RS-01-161

Subject: Additional Plant Systems Information Supporting the License Amendment Request to Permit Up-rated Power Operation, Dresden Nuclear Power Station and Quad Cities Nuclear Power Station

Additional Plant Systems Information Supporting the License Amendment Request to
Permit Upgraded Power Operation (non-proprietary version)

Figure 9-1
DNPS Short Term Core Spray NPSH

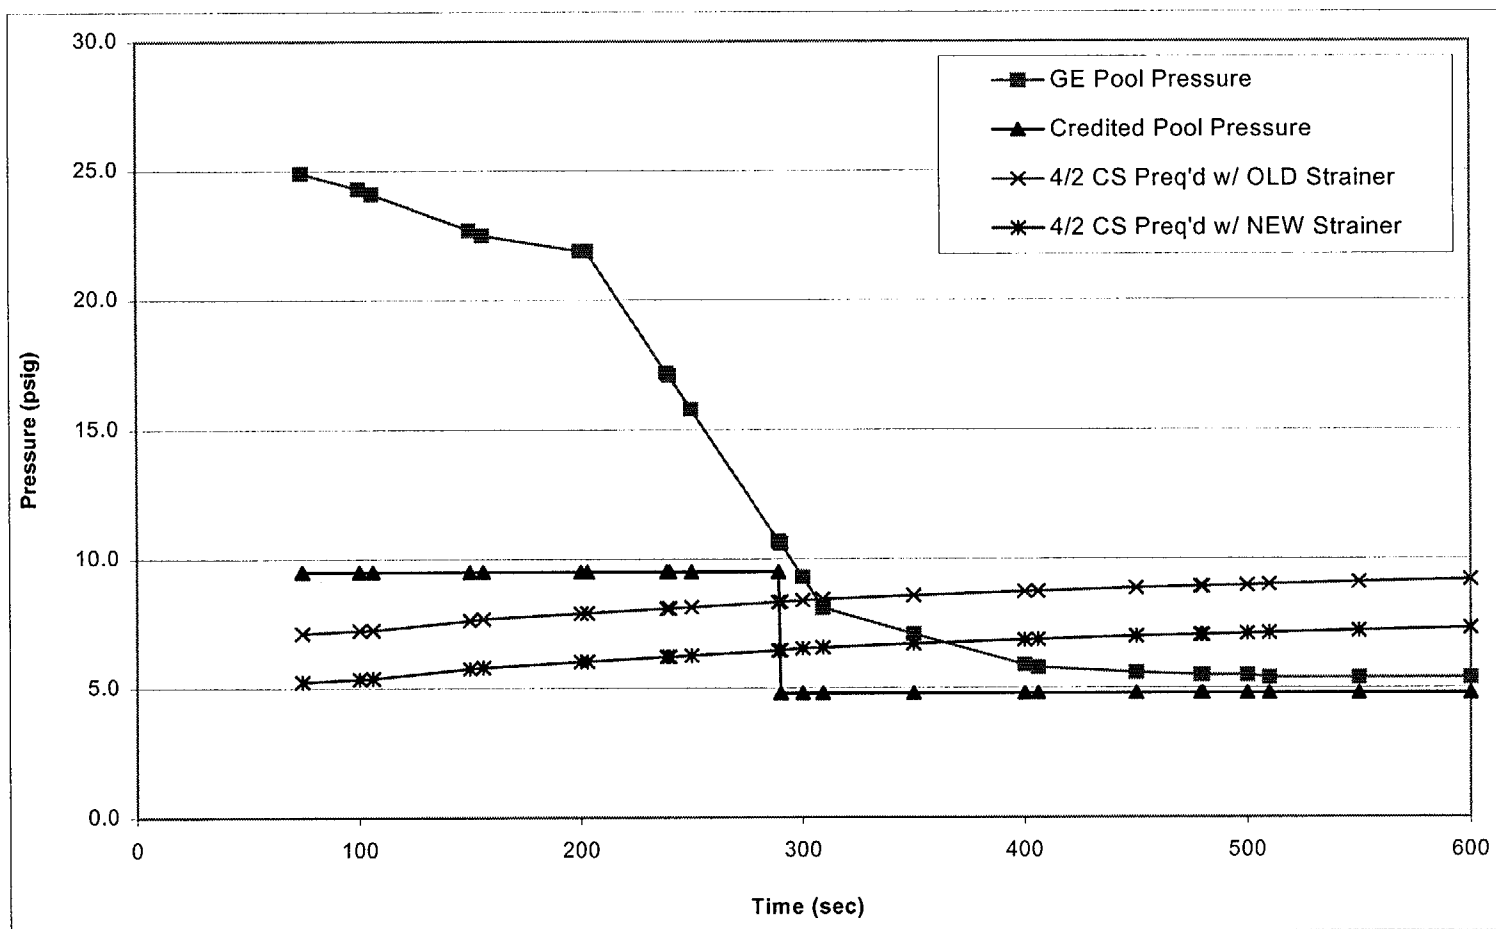
9. Provide the emergency core cooling system (ECCS) pumps net positive suction head (NPSH) calculations to support the requested additional credit for overpressure. Discuss the increased need for containment overpressure for NPSH following a design basis accident. Describe the procedures or equipment in place that will allow continued cooling flow with the drywell potentially depressurized to atmospheric conditions and the suppression chamber at the most conservative pressure associated with vacuum breaker operation (limiting case either torus/drywell or torus/reactor building). Additionally, discuss the methodology for determining the requested containment overpressure, including the headloss across the ECCS suction strainers.

The graphs showing the results of the ECCS NPSH calculations for the limiting short term and long term flow cases are provided in Figures 9-1 and 9-2. Core spray flow is the limiting NPSH case in the short term, and LPCI flow is limiting for NPSH in the long term. Figures 9-1 and 9-2 also show NPSH required (NPSHr) for both the old strainer and new strainer cases (e.g., one blocked, three clean). The higher head loss of the old strainers, as indicated above, is the basis for the requested overpressure.

In the short term, there is a period from approximately 290 seconds to 600 seconds during which some ECCS pump cavitation can occur, since the available NPSH is less than the required NPSH. This period is after the time at which the peak cladding temperature (PCT) has been reached at approximately 240 seconds. Prior to 290 seconds, the requested overpressure ensures that adequate NPSH is available to meet the core cooling requirements assumed in the PCT calculations. After 600 seconds, ECCS pump throttling restores adequate NPSH. Pump cavitation for the brief time from 290 seconds to 600 seconds is not of concern due to short duration of the cavitation.
